DISAPPROVED

CONSTRUCTION

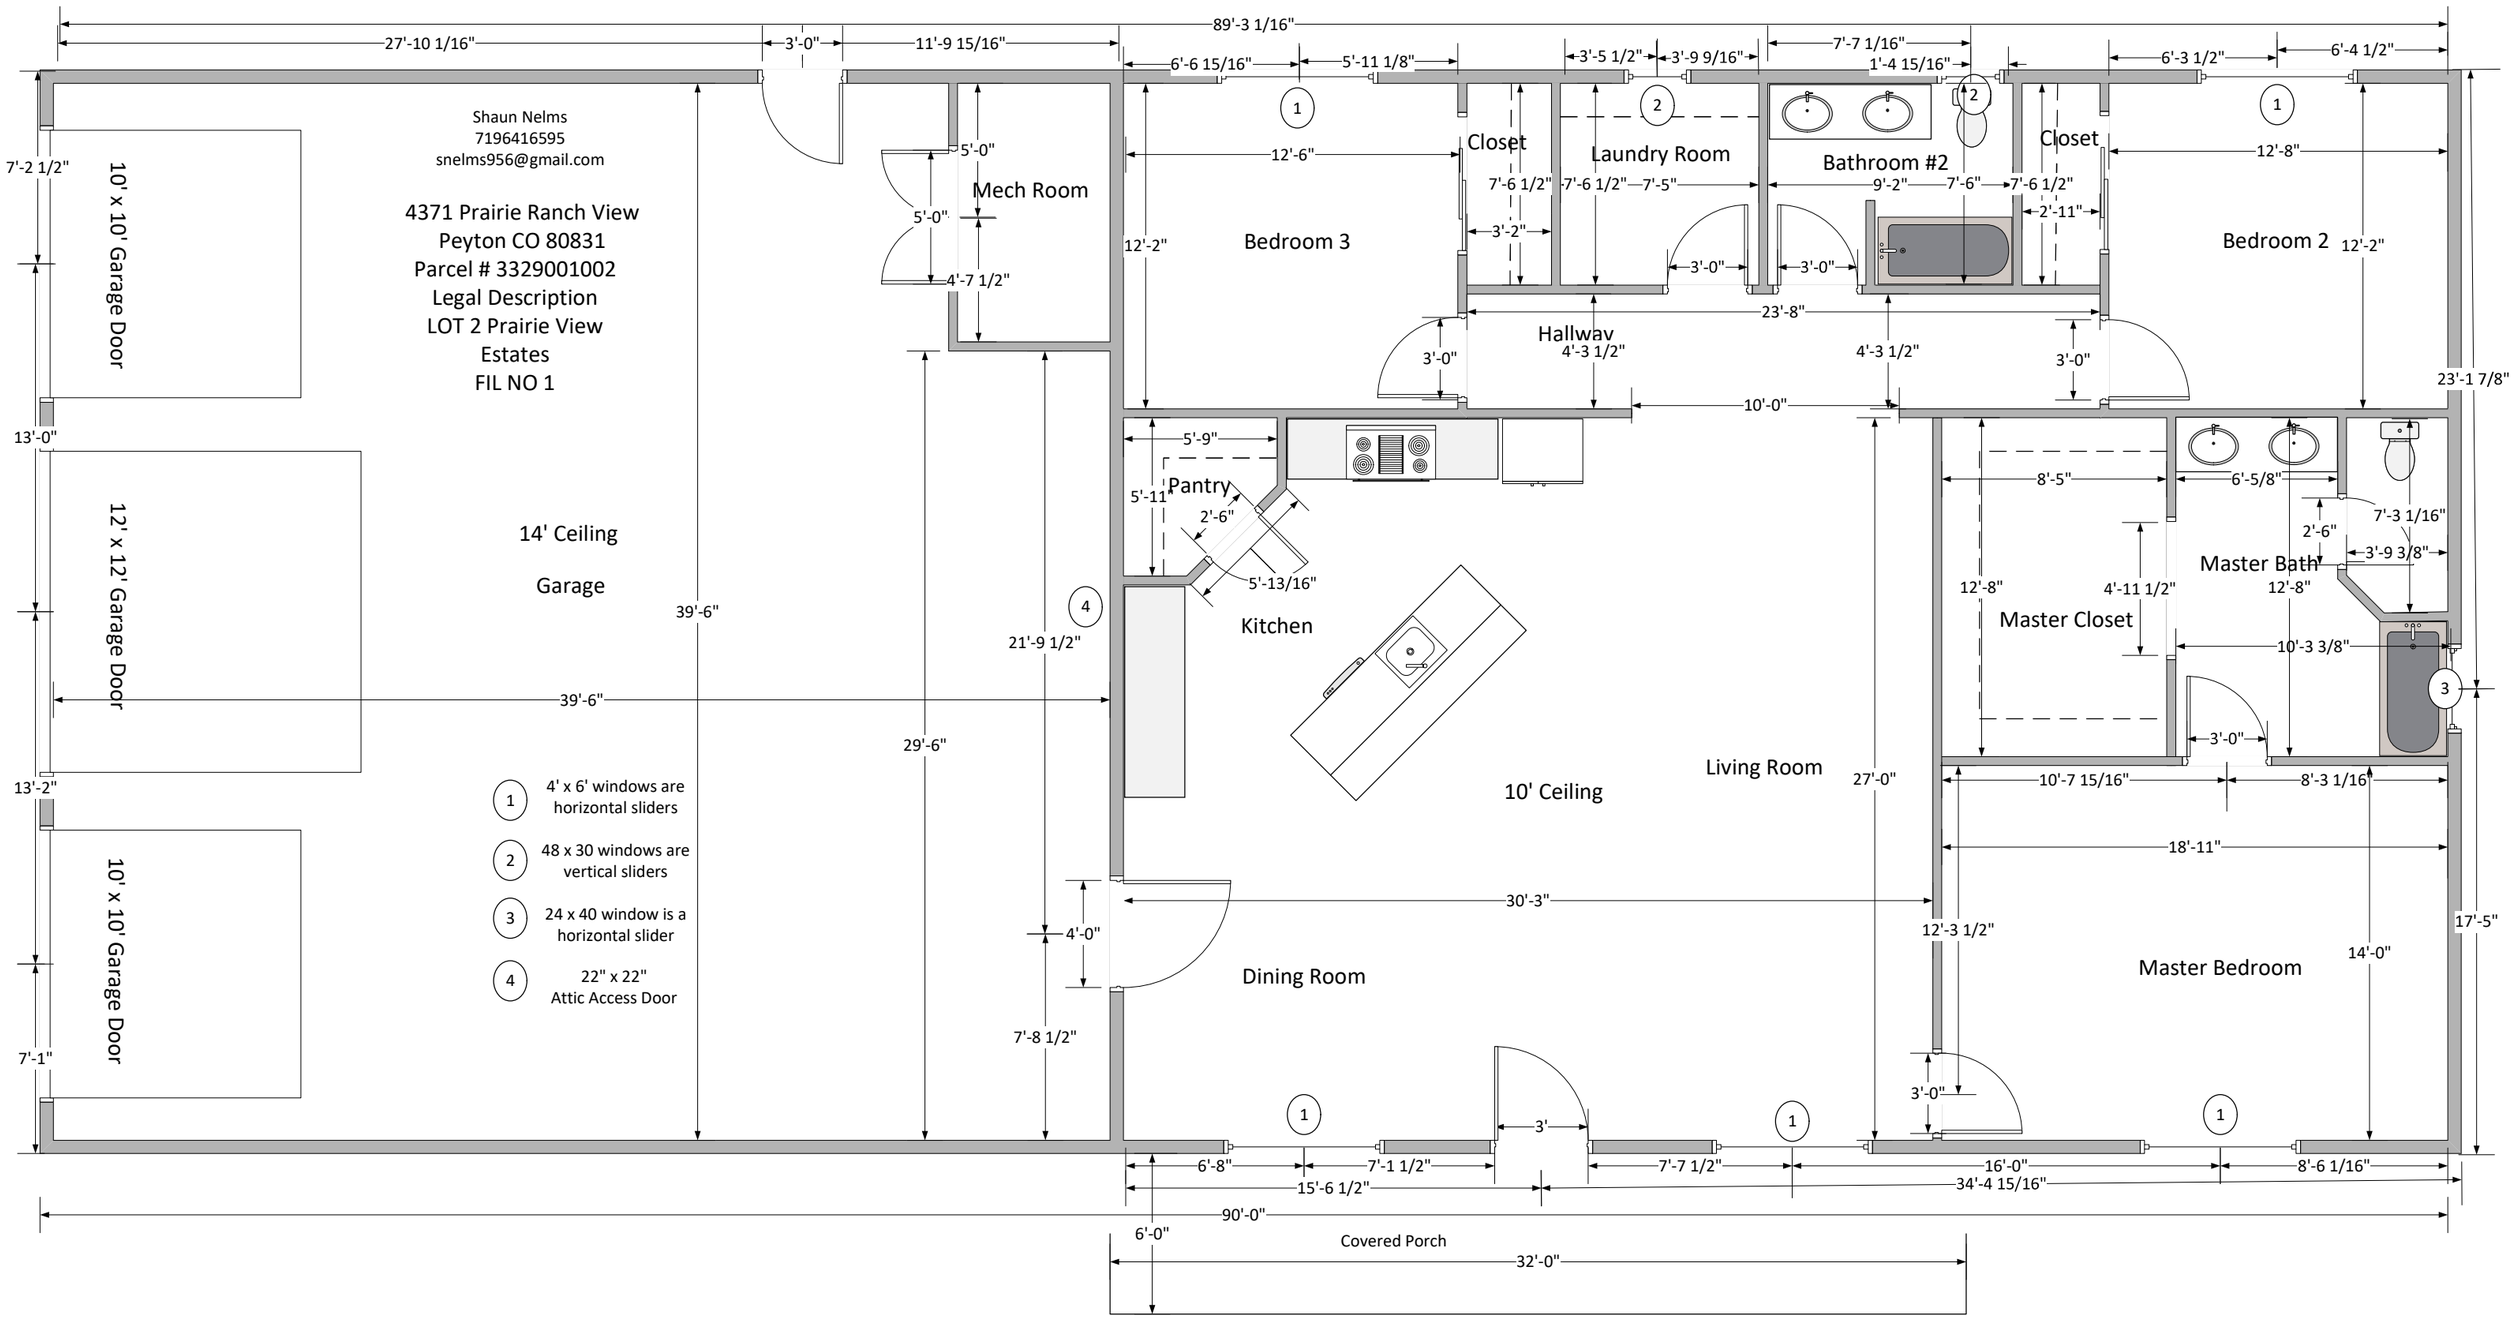
Missing garage/dwelling separation requirements.
Missing smoke and CO alarms.
Missing bath fan.
Missing note for mechanical platform.
Missing architectural wall elevation showing wall construction and the placement of insulation
